ADDENDUM #1:
-ADJUSTED SHEET #
-ADDED ELECTRICAL SHEETS

A1 ADDENDUM #1

NISQUALLY
STATE PARK

PHASE 3A
MAINTENANCE
BUILDING
AND WWTF

PHASE 3A
MAINTENANCE
BUILDING
AND WWTF
GATE LAYOUT -
WWTF

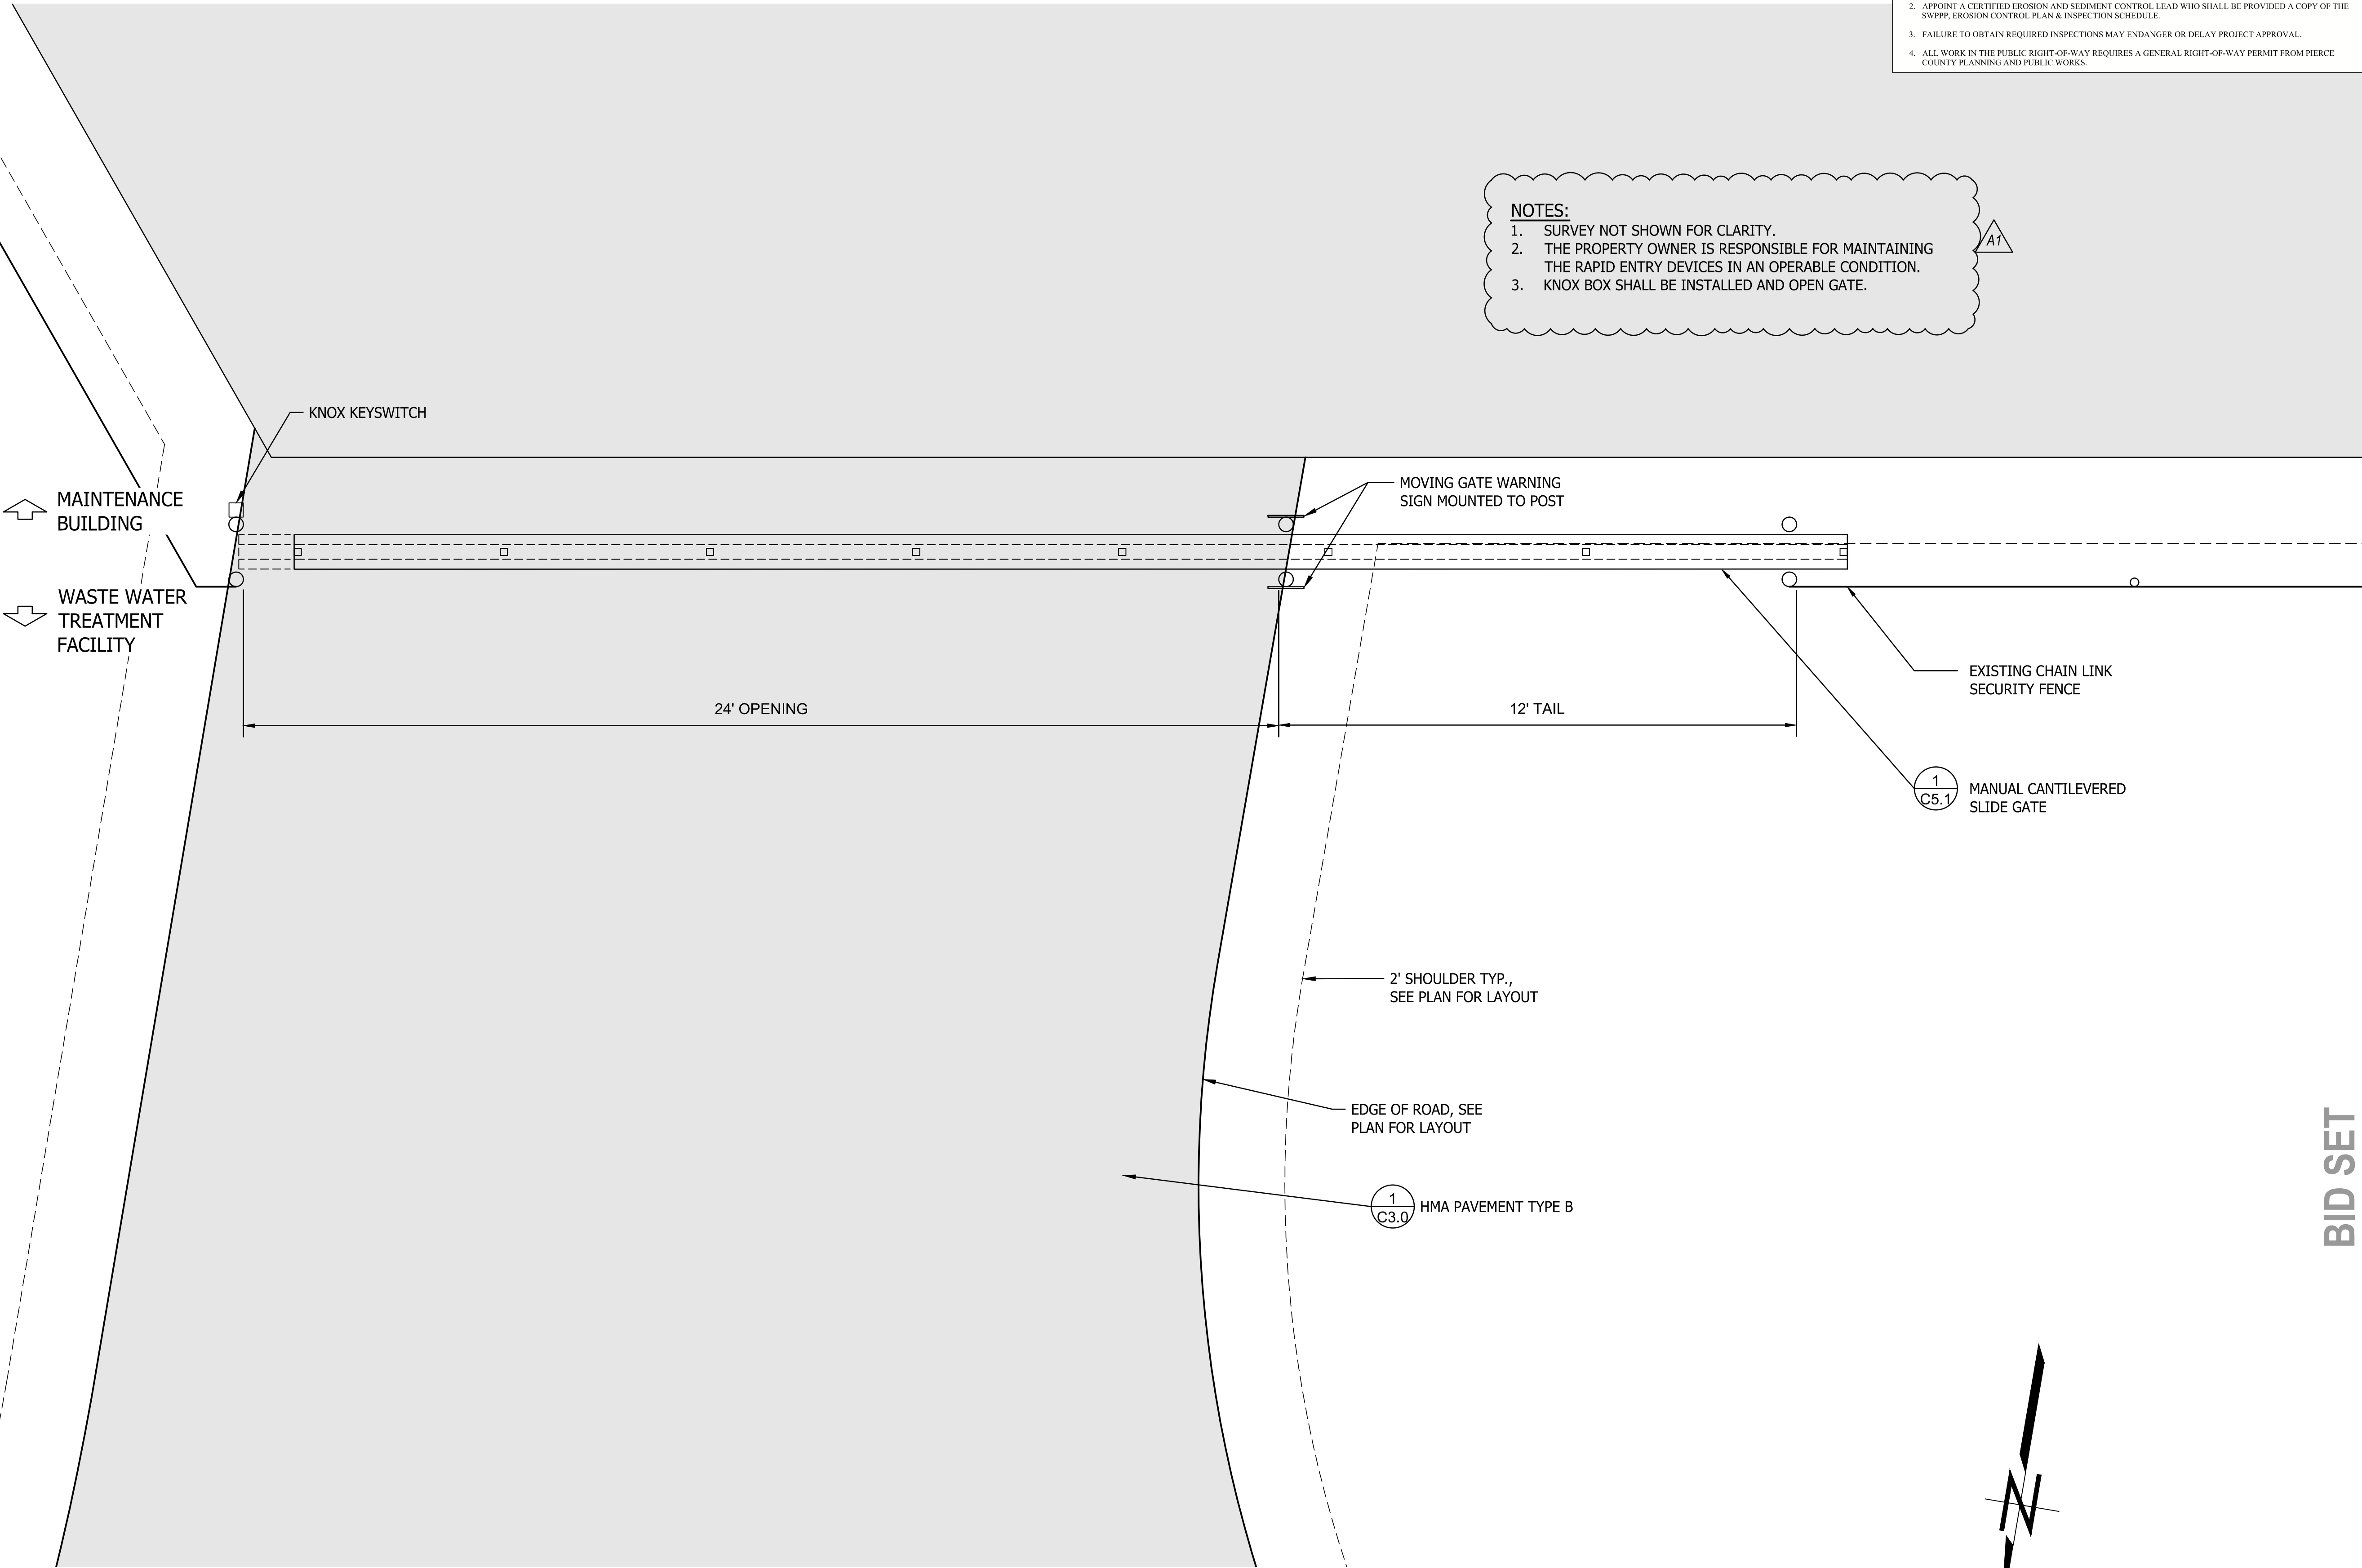
CAD NO.		
6/13/2025	DATE	
	APP.	
	INT.	
ADDENDUM #1: -ADJUSTED TO REMOVE  ELECTRICAL NOTES FOR MANUAL SLIDE GATE.		
REVISIONS		
 ADDENDUM #1		
NO.		
ACTION	BY	DATE
DESIGNED		
DRAWN		
CHECKED (FIELD)		
CHECKED (HDQTS.)
